Central Zoo Authority

Sub:- Design for the construction of various enclosure at Nahargarh Biological Park, Jaipur.

The design for the construction of various enclosures at Nahargarh Biological Park, Jaipur was placed before the 45th Meeting of the Expert Group on Zoo Designing of the Central Zoo Authority held on 30th October, 2013. After detailed deliberation, the following observations were made:-

DRAWING TITLE:
PROPOSED WORKING PLAN FOR LION ENCLOSURE

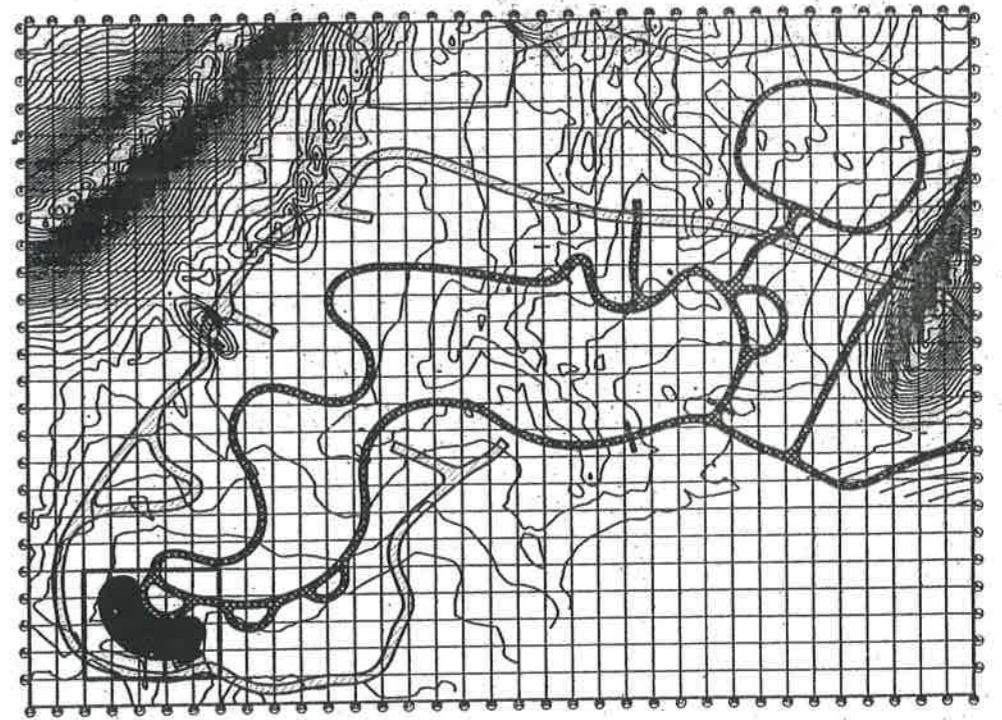
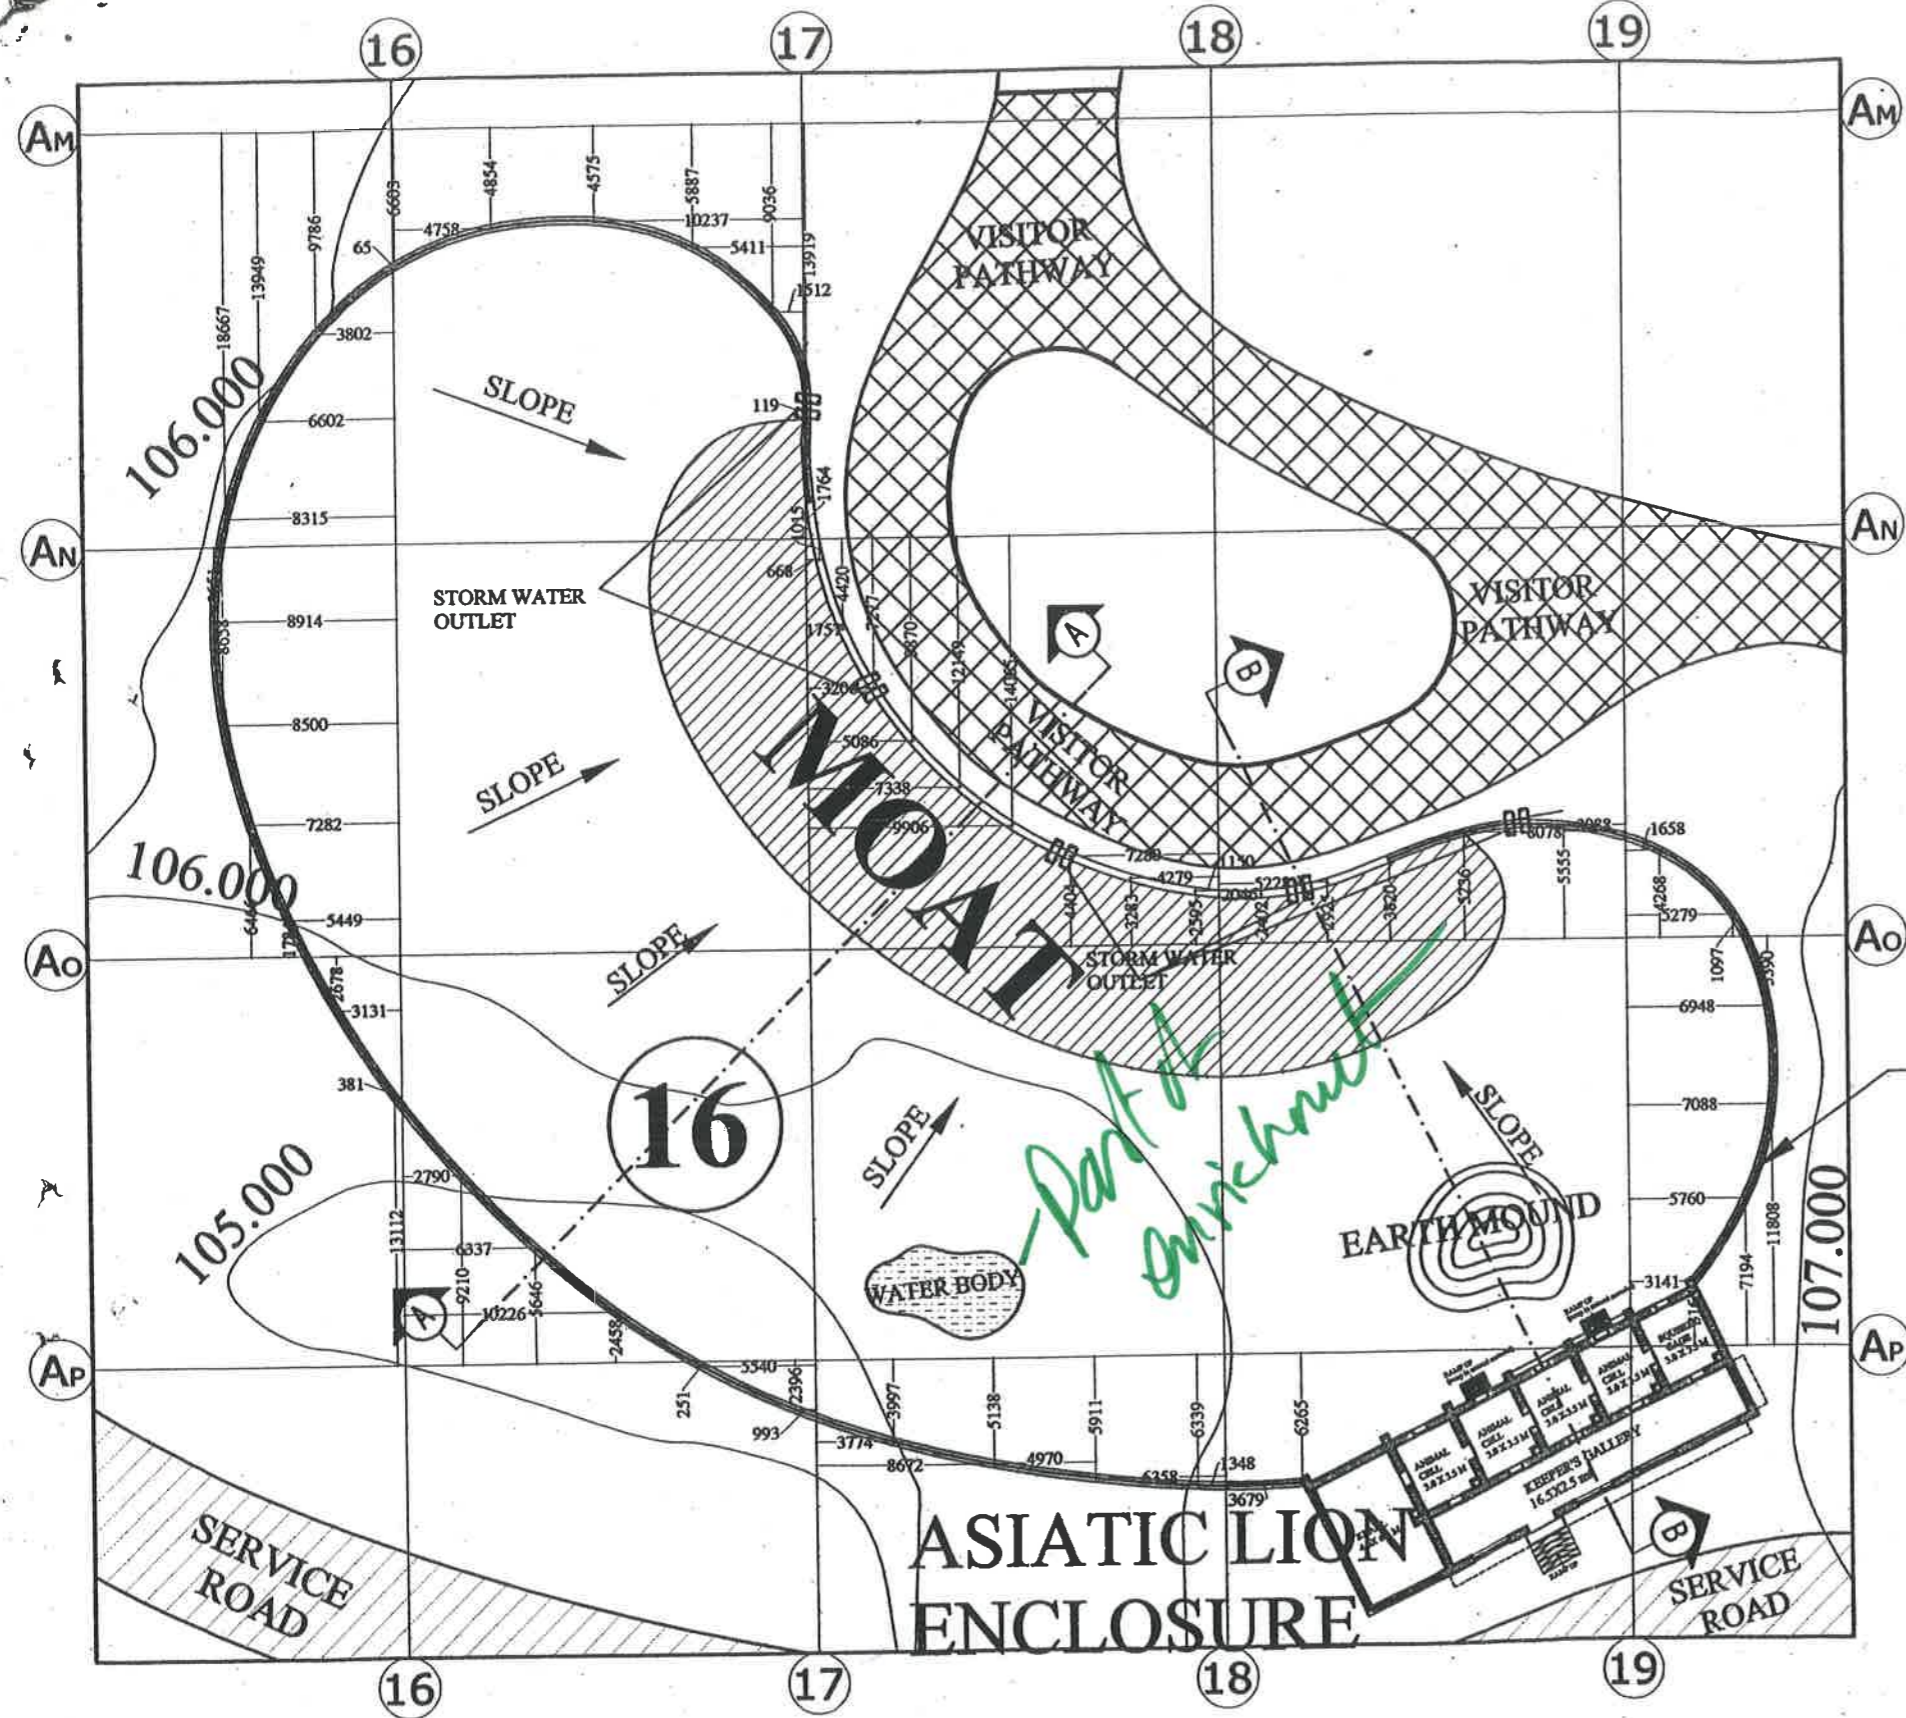
1. Lion (revised design)

The water body etc. is part of the enrichment, since design of the enclosure has already been approved, the zoo director may take necessary action accordingly.
